Maule Aircraft Corporation

Service Letter # 9
Models effected: Bee Dee M-4, M-4 and M-4-210
Mandatory on Serial Numbers:
Bee Dee M-4, 3 thru 14
M-4, 15 thru 94
M-4-210, 1001 thru 1050
FAA Approved

Instruction SheetService Letter # 9

FIG. 1
CONTROL INSTALLATION

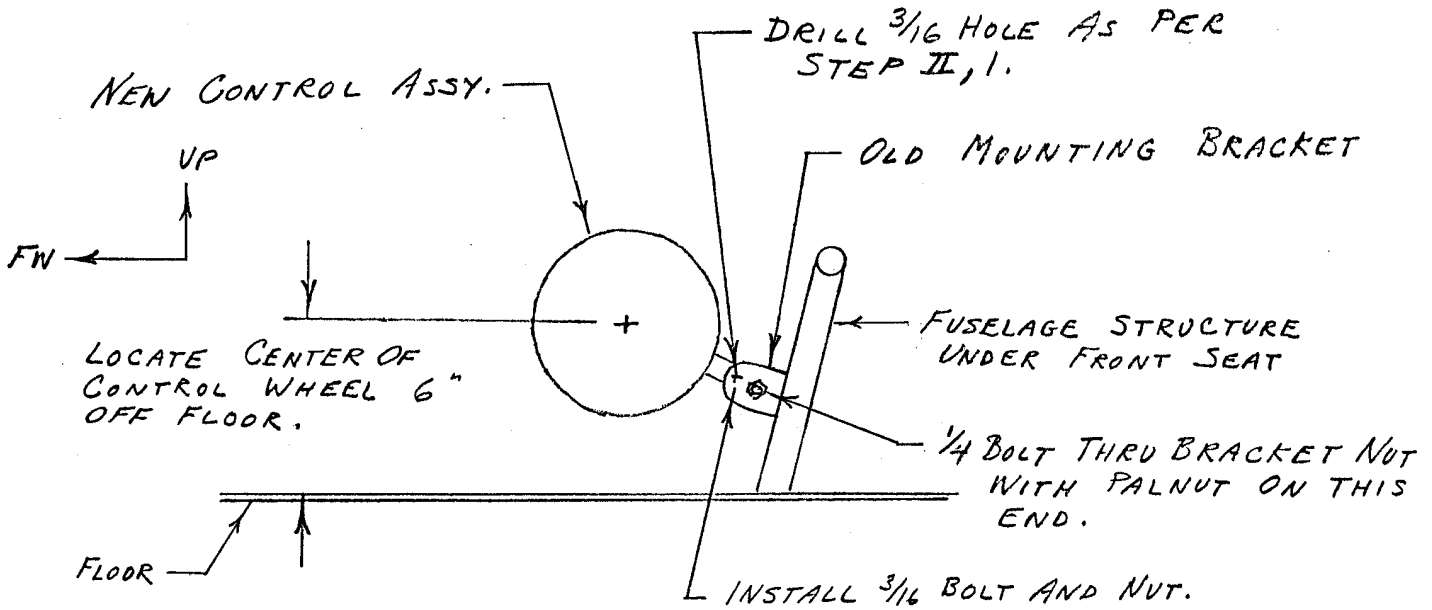
Field Experience has shown a need for a change in our elevator trim control.

1. Install the new control assembly to the old mounting bracket as shown in Fig. 1, by installing the 1/4" bolt and locating the control 6 inches off the floor and drill 3/16" hole thru the mounting bracket, using the predrilled hole in mounting bar as a locator.

2. Install the 3/16" bolt using the hole drilled in Step 1.
3. Remove the fork ends from the turnbuckles and install the turnbuckle eye ends supplied.
4. Connect the turnbuckles to the new control chains as shown in Fig. 2 using the connector links supplied.

INDICATOR INSTALLATION

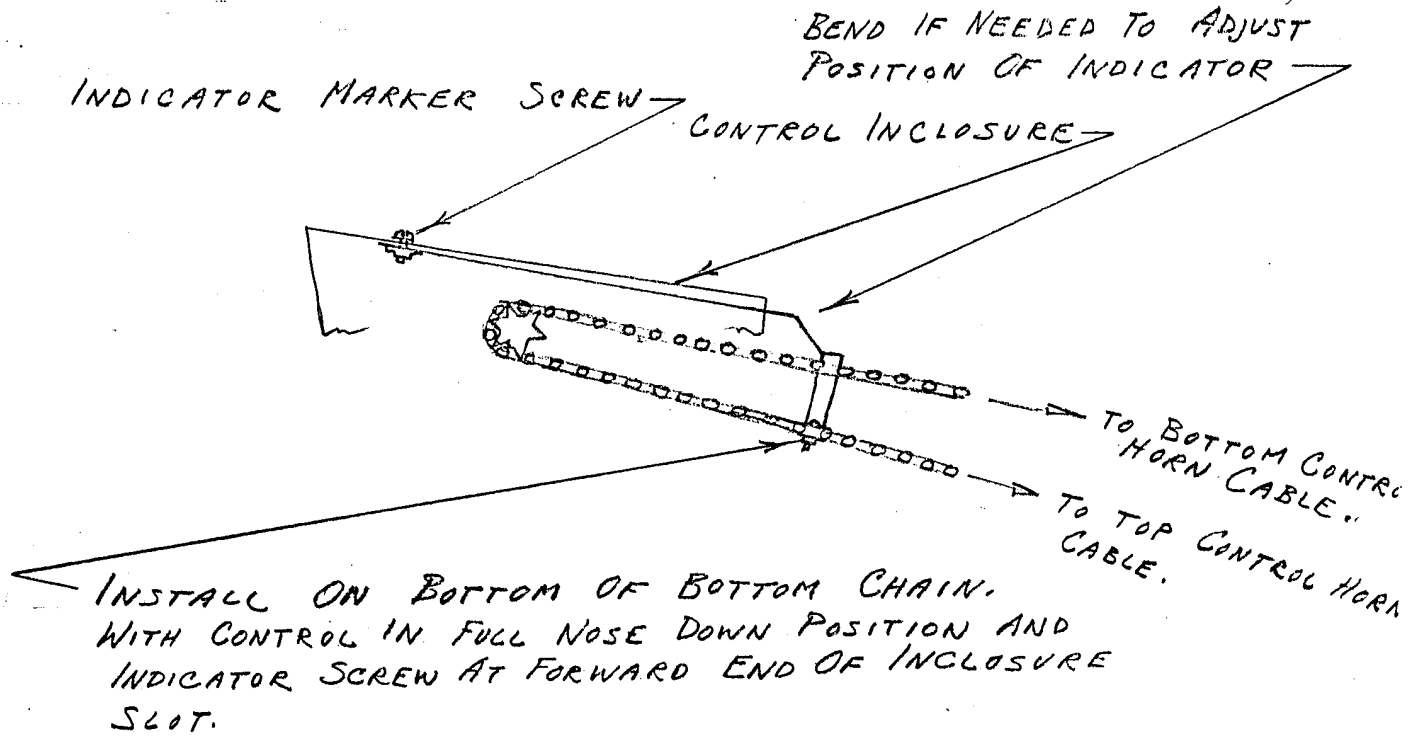
8. Install the tab position indicator as shown on Fig. 2 and check for full travel nose up to nose down stops.
9. Turn control wheel to 0° tab angle and install placard supplied so that the take-off marking is opposite the indicator marker.
